PHOTOGRAPHS

PHOTOGRAPH #5

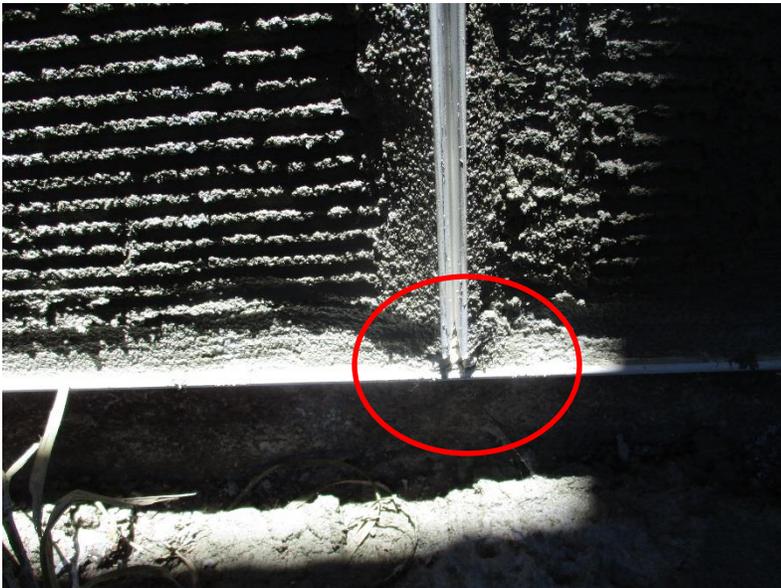
Sub-contractor began scratch coat of stucco prior to completing sealants at accessories transition as specified and has not fully embedded scratch coat into corner beading.

PHOTOGRAPH #11

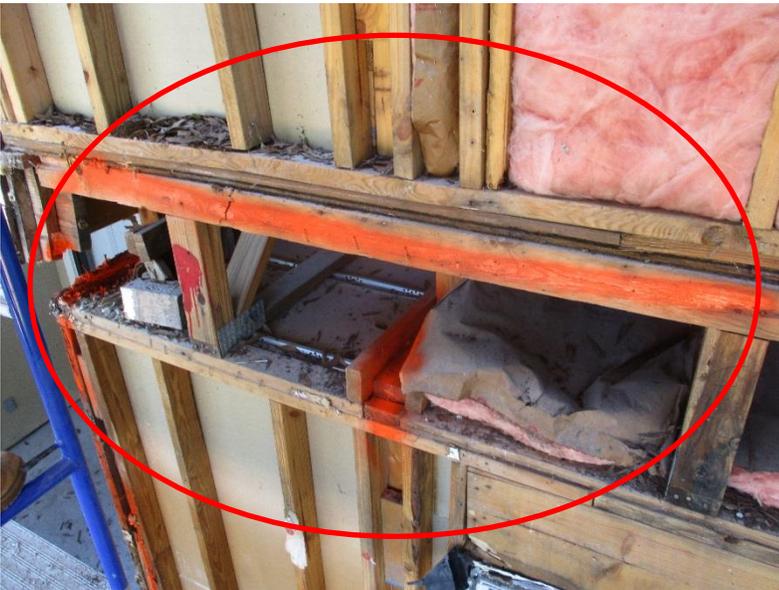
Simpson Strong hardware connectors and strapping has been installed and termite treatment has been applied in preparation for new sheathing.
